Change of the External Appearance of CC-Link IE Field Network Remote I/O Module (with Safety Functions)

NZ2GFSS2-32D

FA-A-0322-A

Before change	After change

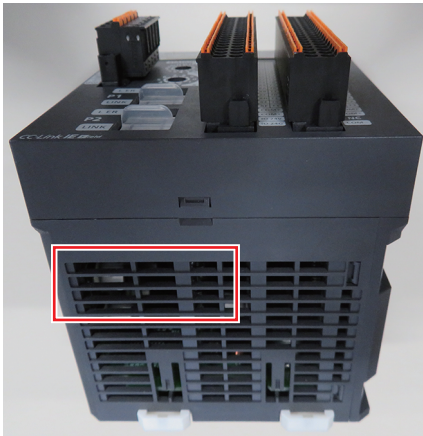
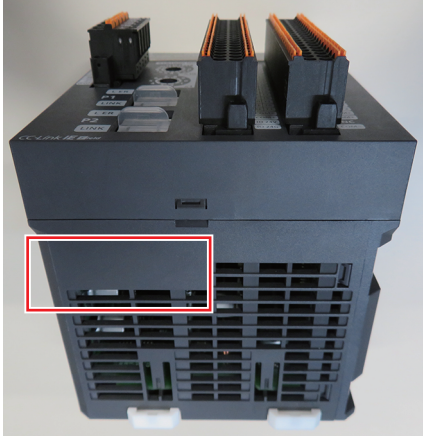
To keep a sufficient creepage distance to improve electrostatic resistance.

The external appearance of the module case will be changed as shown below.
